Planning and Zoning Board Agenda December 10, 2019

SUBJECT: Site Plan - Golf Plaza: A request by Daniel Young, P.E. of CHW, inc., applicant and agent for Nature Valley Harvest, Ltd, property owner, for consideration of a Site Plan to construct three commercial buildings totaling $\pm 25,028$ square feet, with associated paving, grading, drainage, landscaping and infrastructure improvements, on a ± 8.25 acre subject property, located southeast of the Intersection of US HWY 441 and Turkey Creek Boulevard, north of the Turkey Creek Subdivision; Tax Parcel Numbers 05900-004-001 through 05900-004-010 (Quasi-Judicial Hearing).

Planning & Community Development Department Staff Report

SUBJECT: A request for a Site Plan for the construction of three buildings totaling $\pm 25,028$ square feet with employee and customer parking, storm water management facility improvements, paving, grading, landscaping and associated utility infrastructure

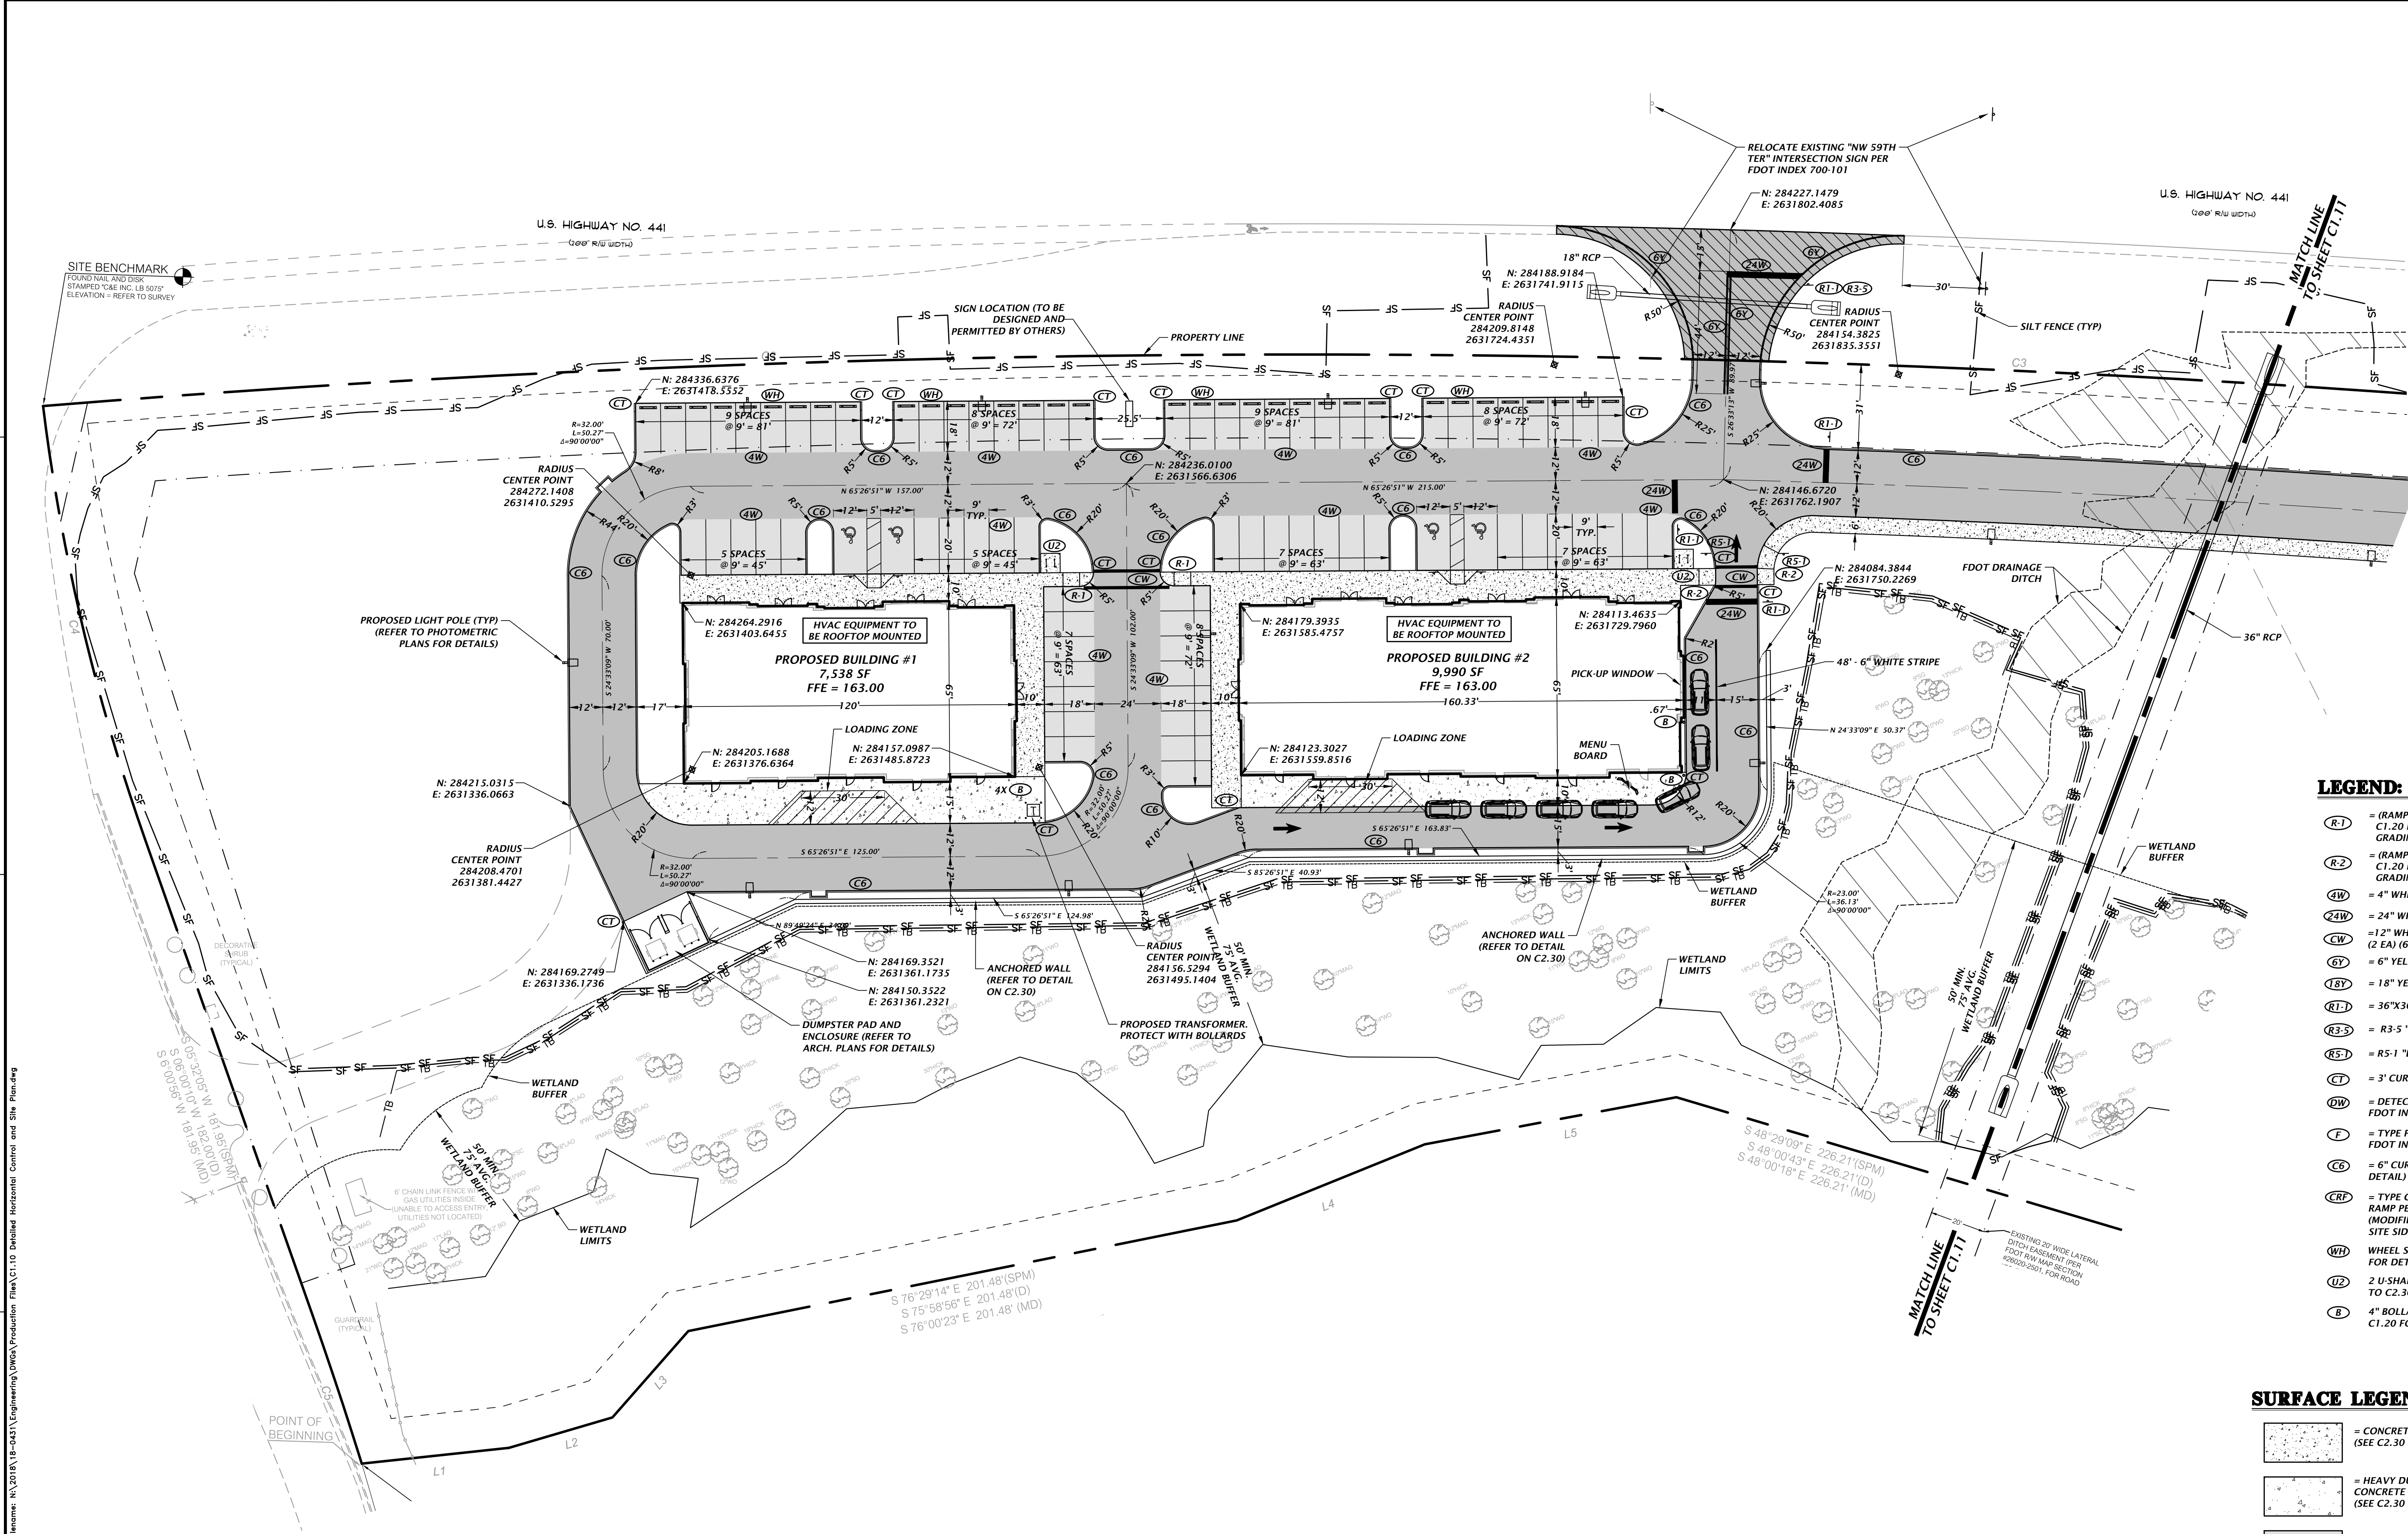
1. The SWPP legend shows the symbol for tree barricade; however this tree barricade is not called out on the plan.
2. The Silt Fence callout on the north side of the property does not line up with the Silt Fence line type in some areas. Please revise
3. The Silt Fence and Tree Protection details are located on Sheet C2.30. The legend states to "refer to C0.22 for SWPP details." Please revise.
4. No detail is provided for the outflow protection.

SHEET NO.:
C1.20

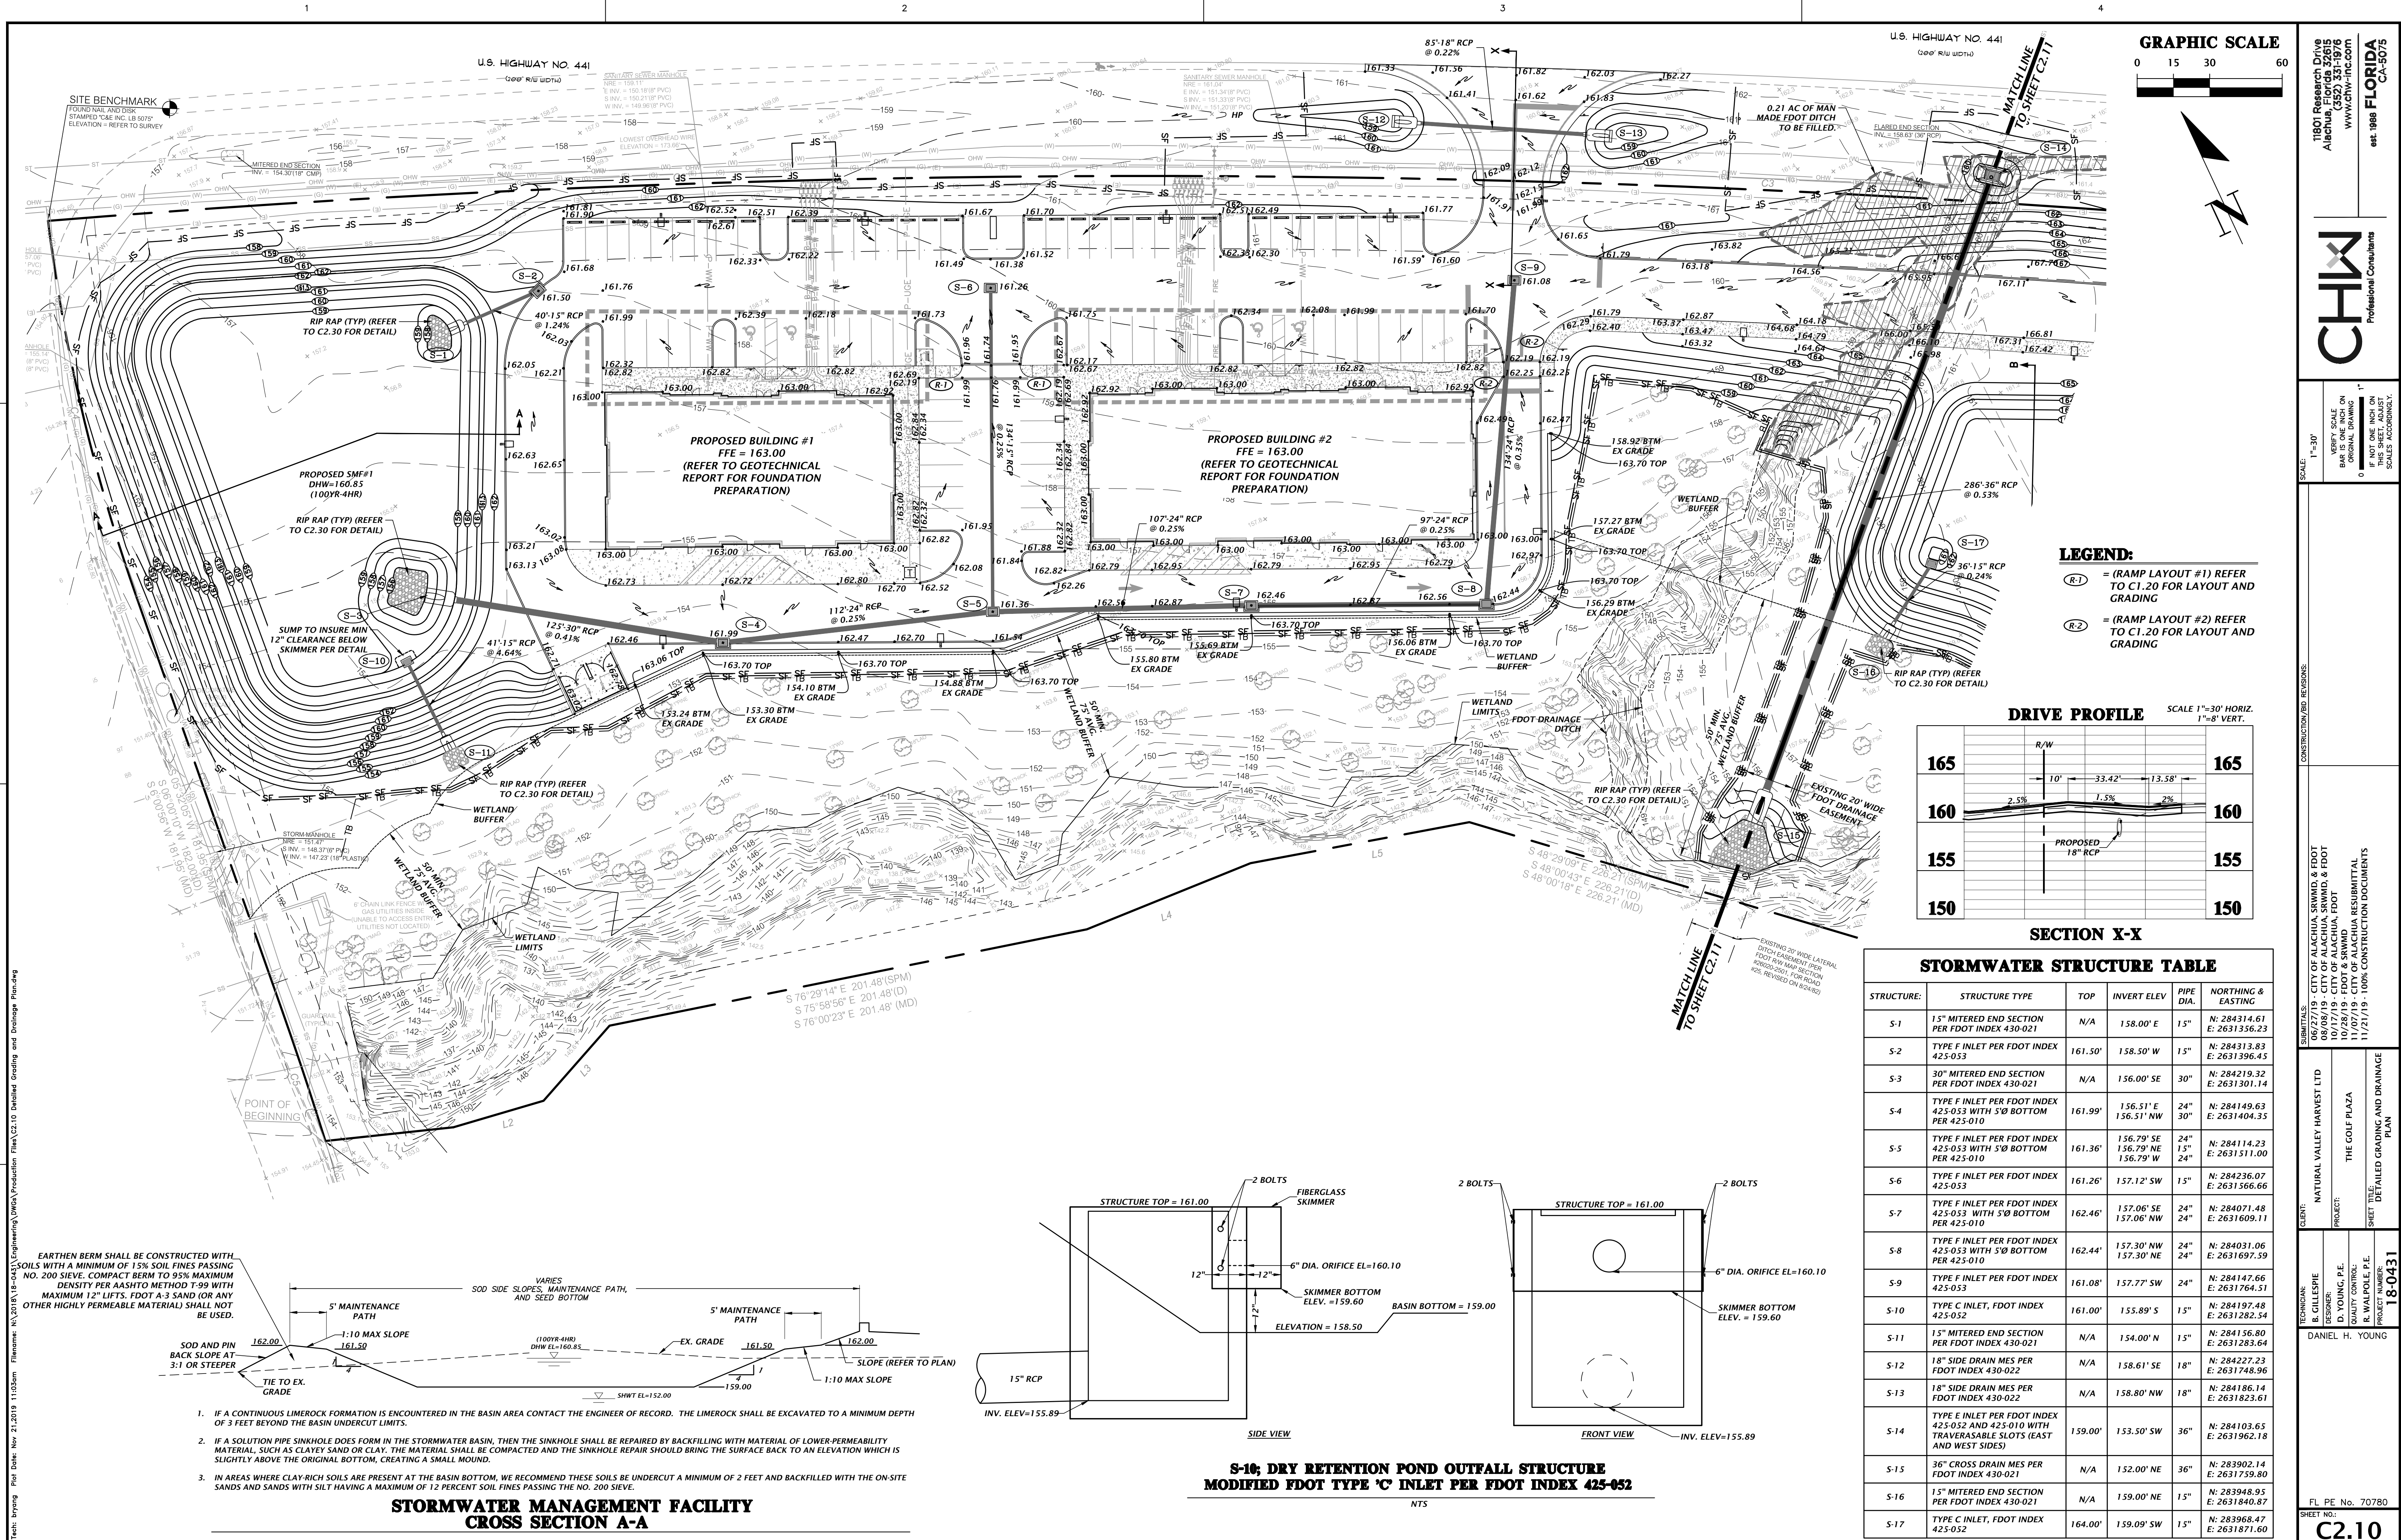
- 1. Will telecomm lines along US Highway 441 frontage be raised? They appear to be relatively low, which may be damaged by larger trucks/ emergency vehicles.
- 2. "XX Zoning" referred to on site plan cover sheet should be updated to reflect PUD zoning district.
- 3. Sheet C0.10, General Note 14 is not applicable.
- 4. Sheet C0.10, General Note 25 should reference FDOT and/or the City of Alachua Public Services Department.
- 5. Paving and Grading General Note 8 should reference City of Alachua Public Services.
- 6. HC pavement marking detail on Sheet C1.20 is not legible (dark).
